From: [Harmon Rita T.](#)
To: [Fred c. Arfman \(freda@iacivil.com\)](#); "[Genny Donart](#)"; [Bryan Bobrick](#)
Cc: [Olson, Paul L.](#)
Subject: B18D001C - Northpoint Townhomes
Date: Friday, July 08, 2016 8:37:02 AM

Based upon the information provided in your submittal received 6-10-2016, the above referenced plan cannot be approved for Building Permit until the following comments are addressed:

Supplemental Information

North I-25 Apartments

Proposed Drainage Basins:

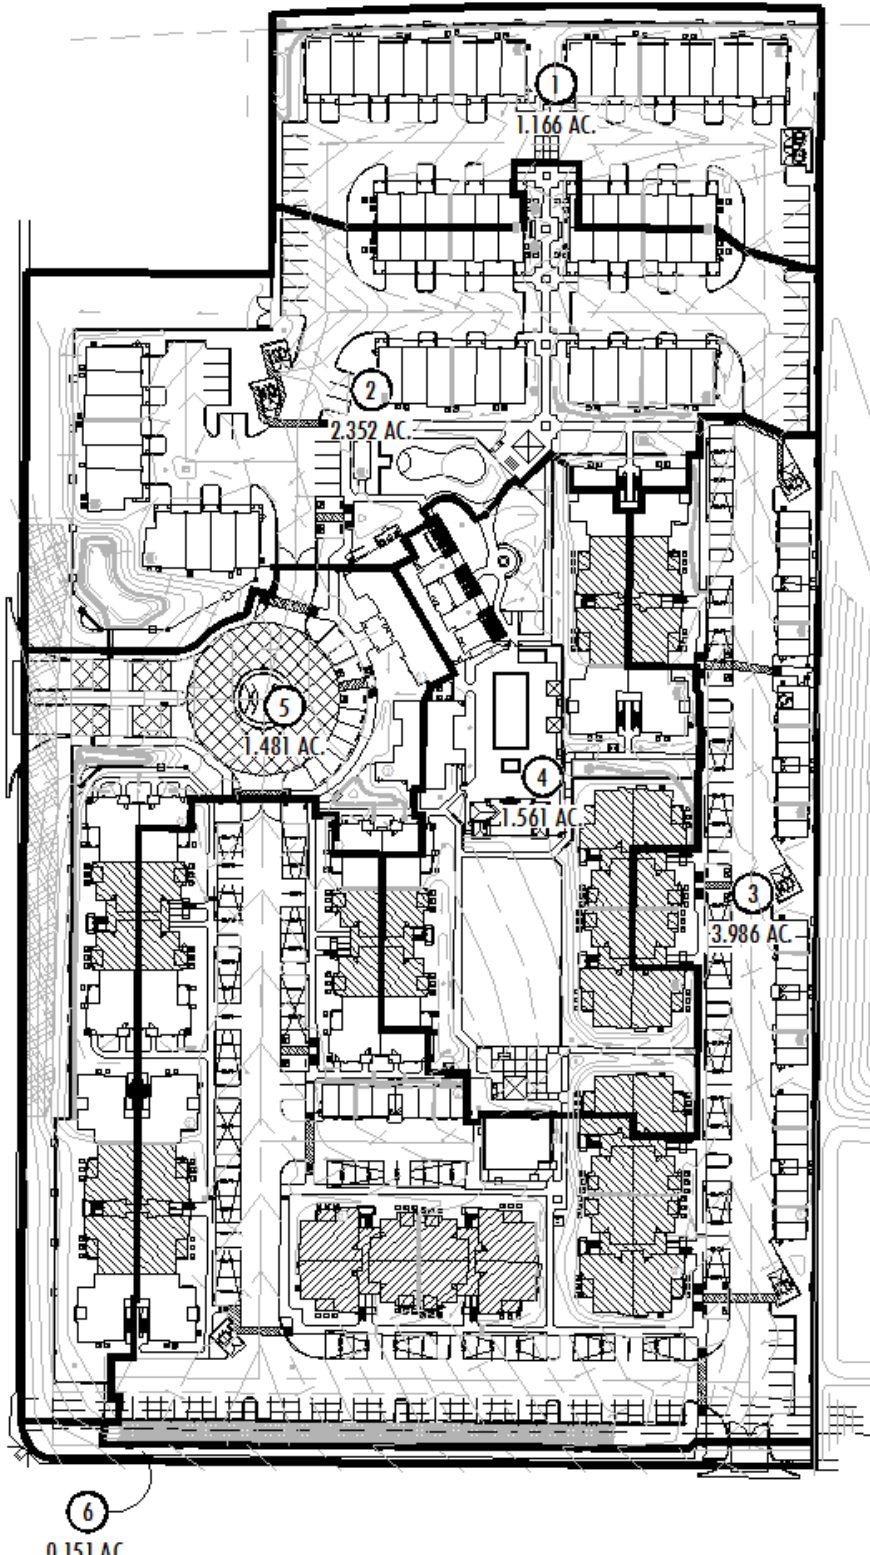
- The DMP basin boundaries need to be modified to match the basins for this site. (The Triangular area discharging to San Mateo should be divided to that flowing north and that flowing south). Show the high point in the road.

- Discharge from the northern basin, Basin 1, discharges 5.2 cfs into an existing road. Provide a swale that directs flows across the PNM site and onto the curb return.

CG1.0

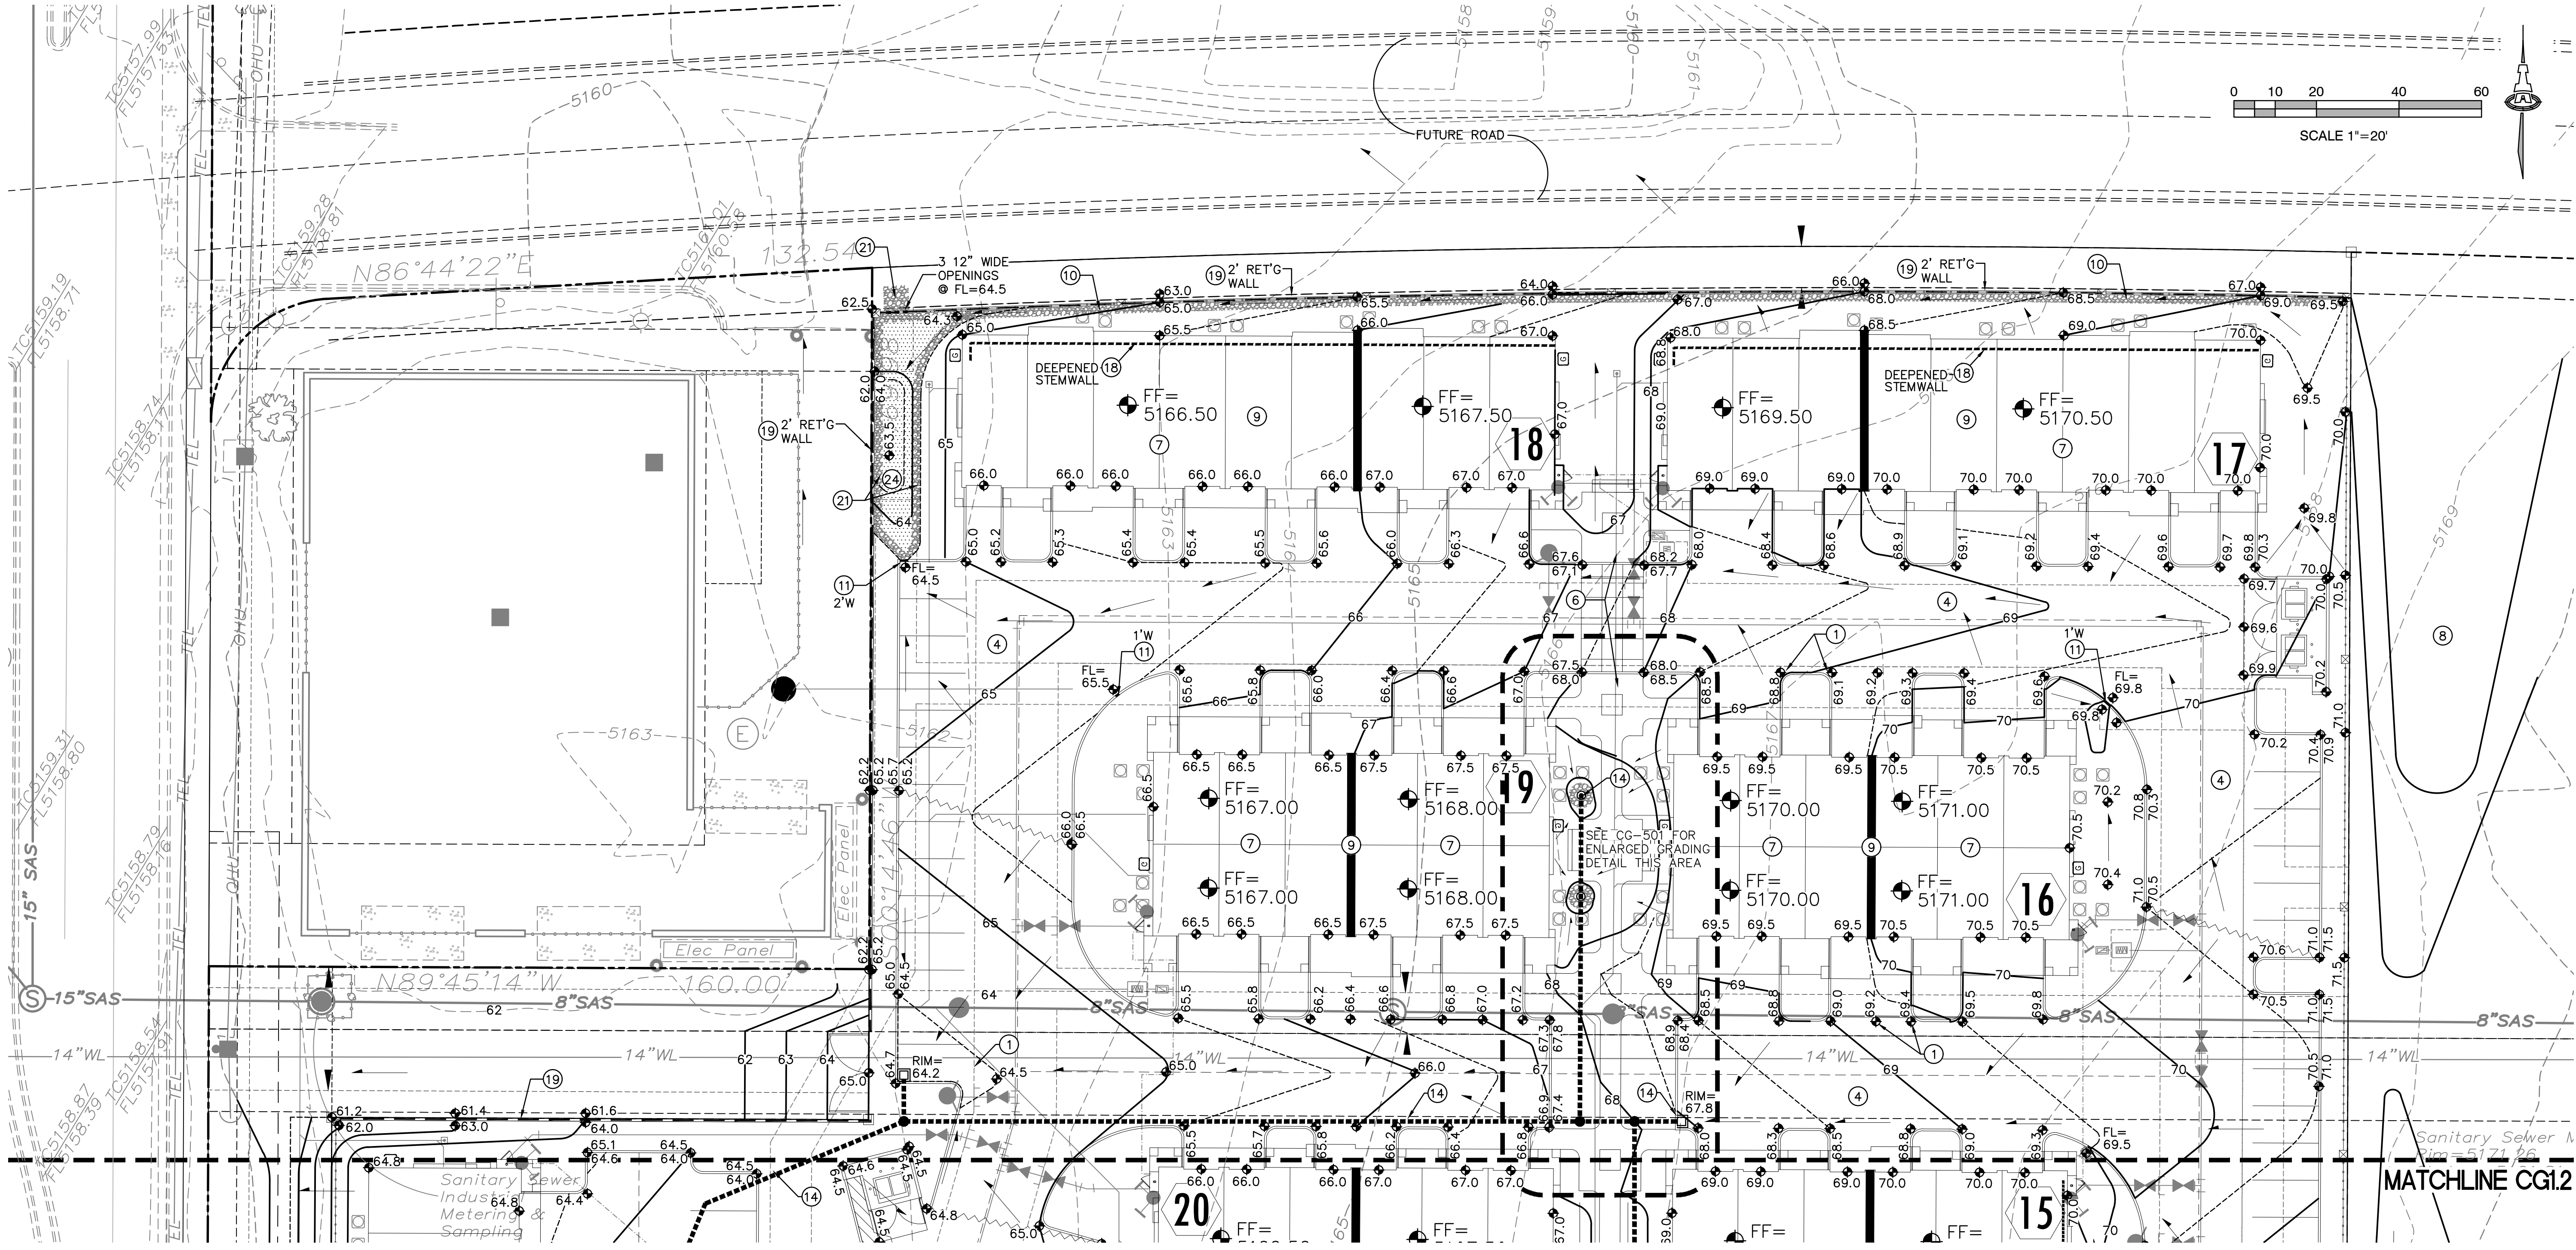
- Preliminary calculations for the hydraulic structure are required prior to sign off on the Work Order/DRC set.
- Label off-site contours at NE corner, and provide additional contours to show how the offsite flows are directed in this corner.

CG1.1

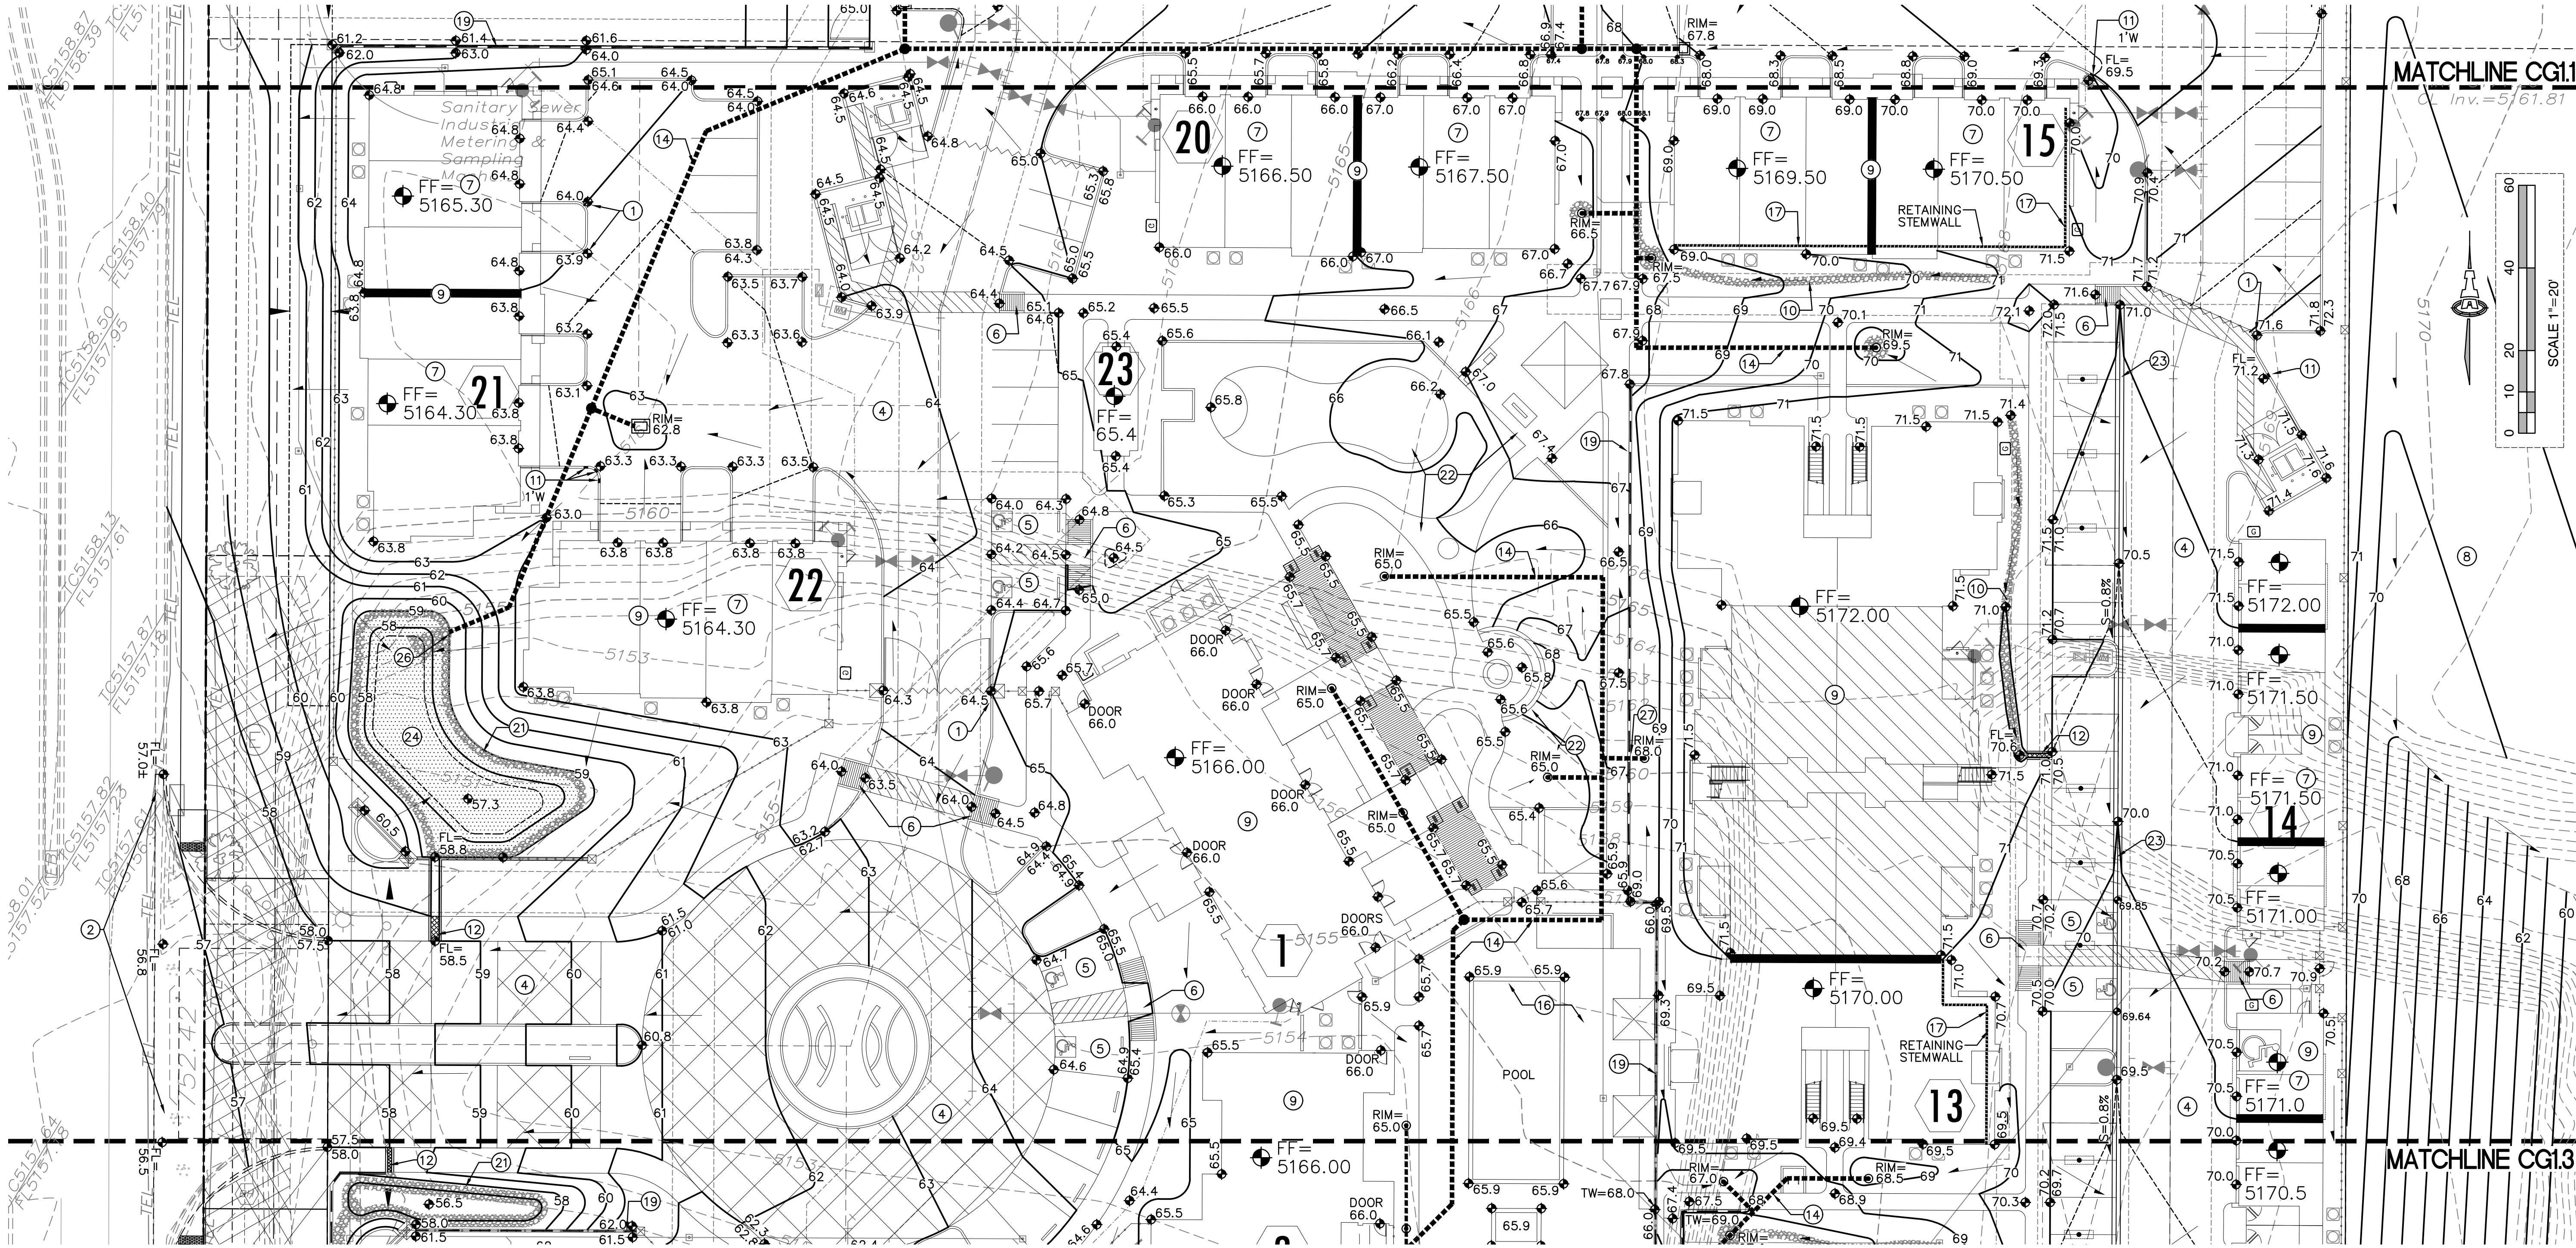
- On Sheet CG1.1, a reference is made to enlarged plan on CG-501 rather than CG5.1
- Building and structure perimeters need to be better defined by using a heavier line weight
